Re: 107-115 Great Road - SSPS 07/10/09-422
Wetherbee Plaza II - Minor Modification

SKETCH PLAN OF PROPOSED EQUIPMENT RAMP

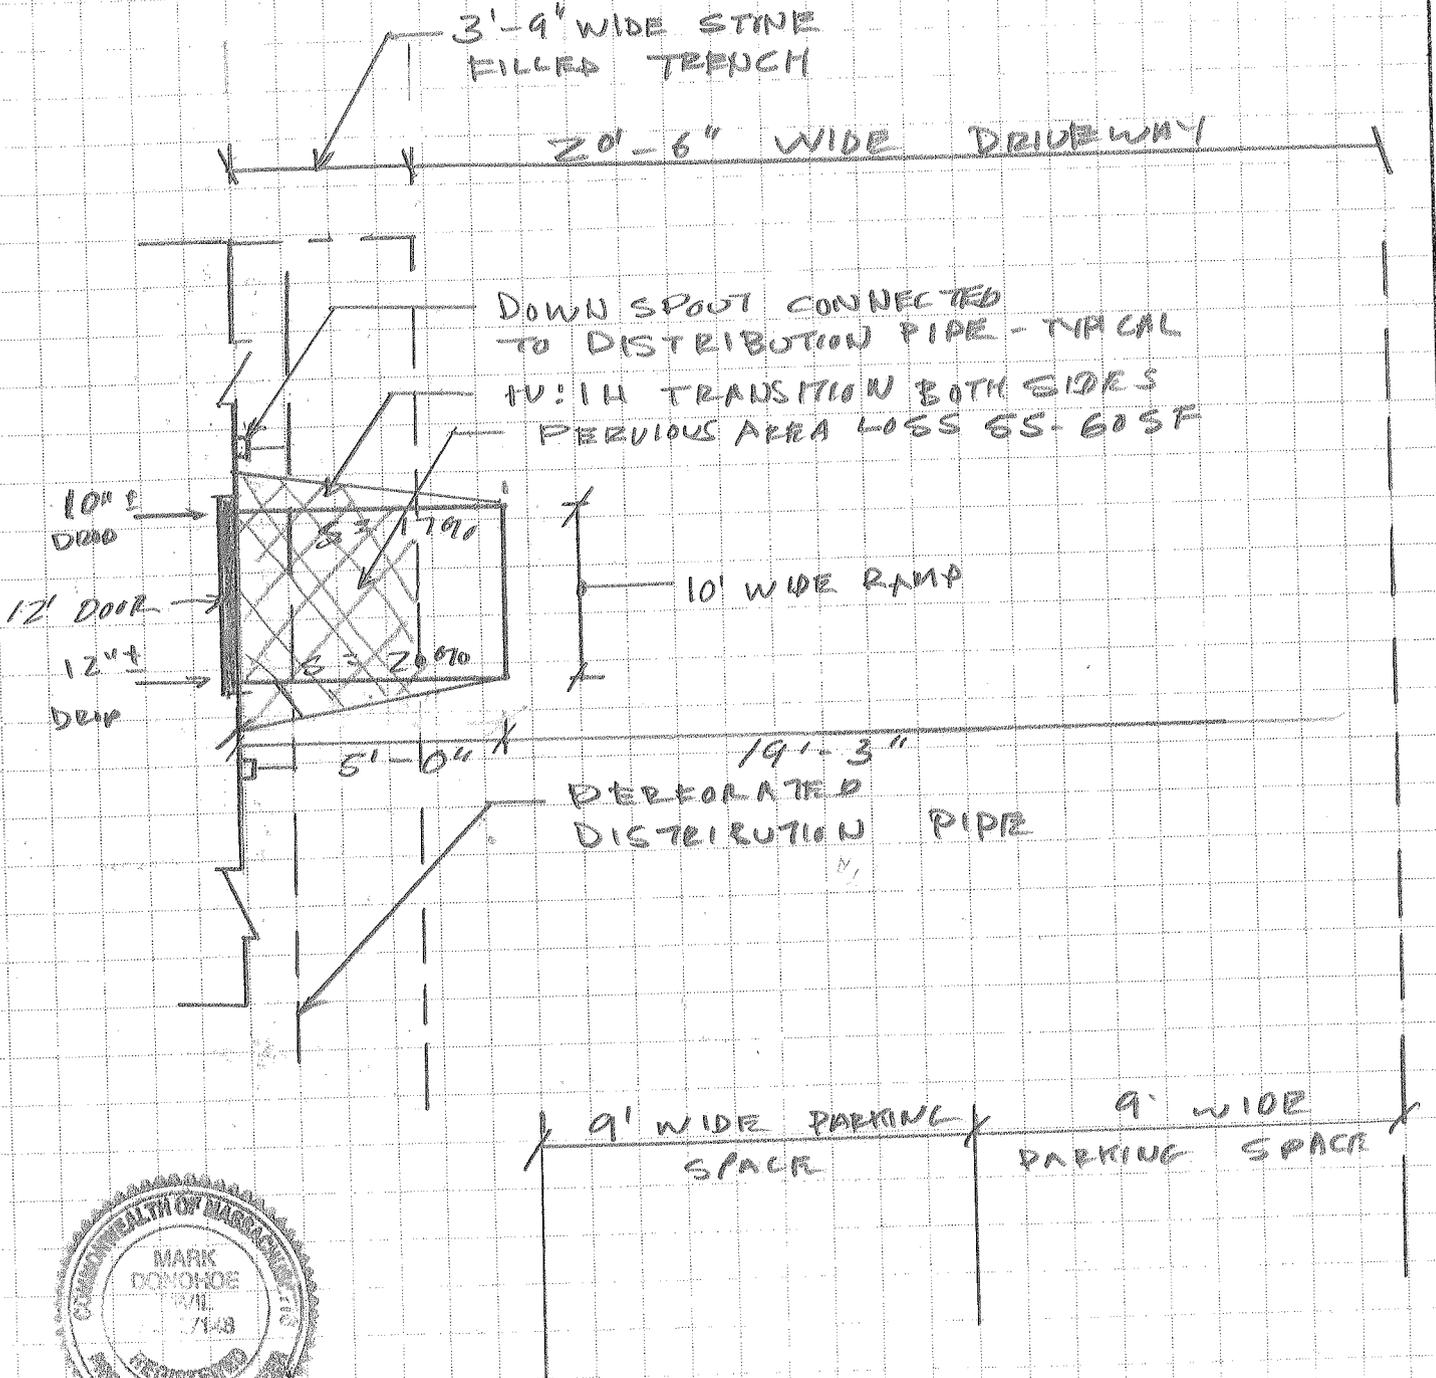
The ramp is shown on the attached sketch plan and is to allow a reasonable transition from the existing bituminous concrete pavement to the buildings floor slab. The elevation difference between the driveway and floor slab ranges from 10 to 12 inches and the installation of a 5 foot long ramp will result in an average ramp grade of 18.5 percent

The ramp will be 10 feet wide to allow full access to the proposed 12 foot wide door to allow for full and safe access for the movement of equipment.

The five foot long ramp will not compromise the accessibility of the two, 9 foot wide parking spaces at this end of the building.

As shown by the sketch plan a driveway width of 19'-3" is available at the ramp and allows for full access for the two 9' wide parking spaces at this end of the building.
